BULLETIN - 3000 SERIES ZEUS SKEG KIT 21-SEP-2012

2015-08 SEPTEMBER 2015

ORIGINAL

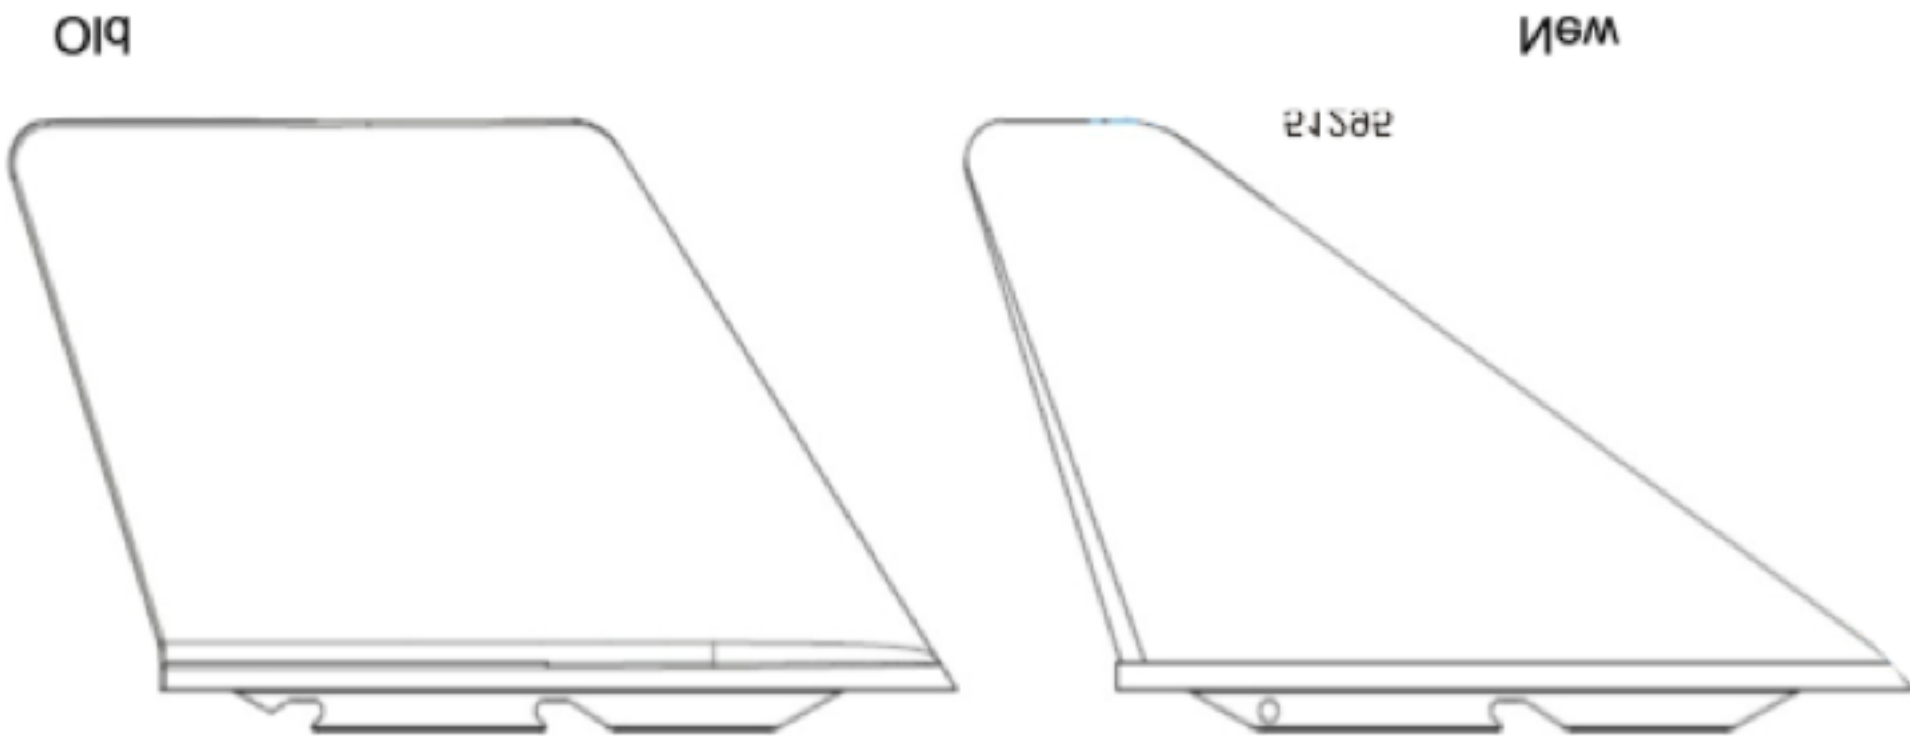
been changed from a roll pin to a solid pin design. This new skeg was implemented on pod serial number 0M988382. The angle of the leading edge of the skeg has been increased, and the pin has been redesigned to provide for improved retention. To resolve instances of skegs falling off due to the pin becoming loose and falling out, the Zeus 3000 skeg and pin have been

- Kit supersedes 878345T27, once existing stock is used up.
- Includes skeg, two pins, and instruction sheet.
- Kit number 8M0075888.

Skeg kit fits all HH, IH, and JH series pods.
